WELL API NO. 30-015-43979
5. Indicate Type of Lease STATE <input checked="" type="checkbox"/> FEE <input type="checkbox"/>
6. State Oil & Gas Lease No.
7. Lease Name or Unit Agreement Name Lobo 285 State SWD
8. Well Number 001
9. OGRID Number 371643
10. Pool name or Wildcat SWD; Devonian-Silurian

This sundry requests a change of pipe as originally proposed and permitted.

WELL SCHEMATIC - PROPOSED
Lobo 285 State SWD Well No.1

Re: Request for Tubing Design Change for Solaris Water Midstream, LLC's Lobo 285 State SWD No.1, API No.30-015-43979, as Specified by Division Order SWD-1663.

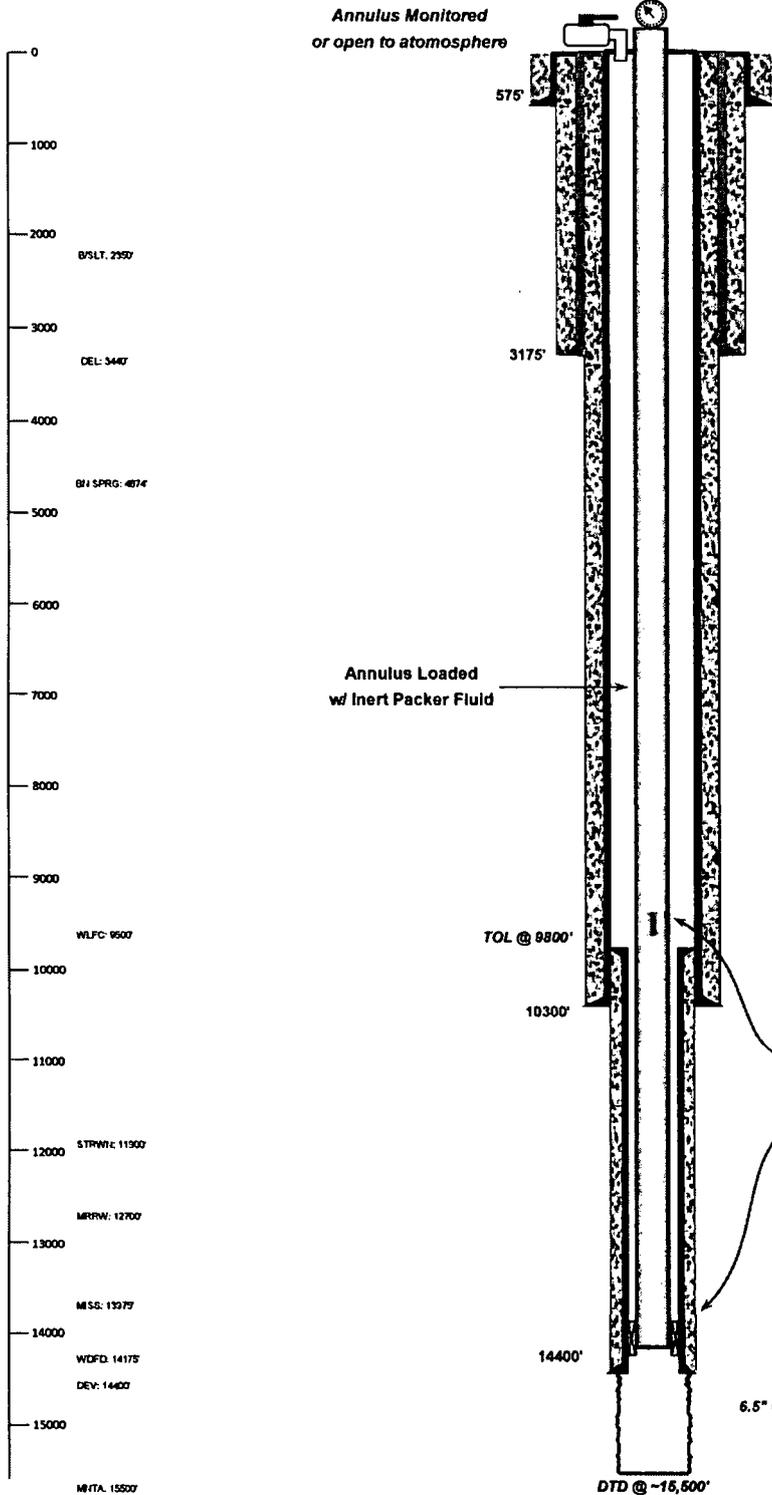
The well was originally proposed w/ 7.0" Liner from 9800' to 14400'. Solaris intends to upsize the liner to 7.625" which is in line with the currently permitted designs. ALL SETTING DEPTHS REMAIN THE SAME.

The upsized liner will allow for a 5.5" to 5.0" tapered string to be utilized in this well to be configured as all other recently permitted Solaris SWDs. Tubing size increase request will be submitted to the Engineering Bureau in Santa Fe to coincide with this sundry request to increase the liner size.

Solaris Water Midstream is currently drilling its Lobo 285 State SWD No.1. The well was originally proposed and permitted with 7.0 inch liner and 4.5 inch tubing however; the well design configuration currently being utilized and permitted calls for a liner size of 7.625 inches thereby allowing for the installation of a 5.5/ 5.0 inch tapered tubing string.

Solaris seeks to optimize overall operations and individual well efficiency. By installing larger tubing, friction pressure loss will be reduced thereby improving the potential capacity of the well. To this end, we hereby respectfully request that the SWD-1663 be modified to allow for larger 5.5 inch tubing, transitioned to 5.0 inch flush joint tubing approximately 60 feet above the top of the liner.

5.5" to liner w/ 5.0" Flush Joint inside liner
 IPC Tubing set in PKR ~14,300' +
 (Within 100' of Uppermost Disposal Interval)

7.625", 39.0# P-110 Csg (8.5" Hole) 9,800' to 14,400'
 675 sxs Cls H - TOC @ Top of LNR
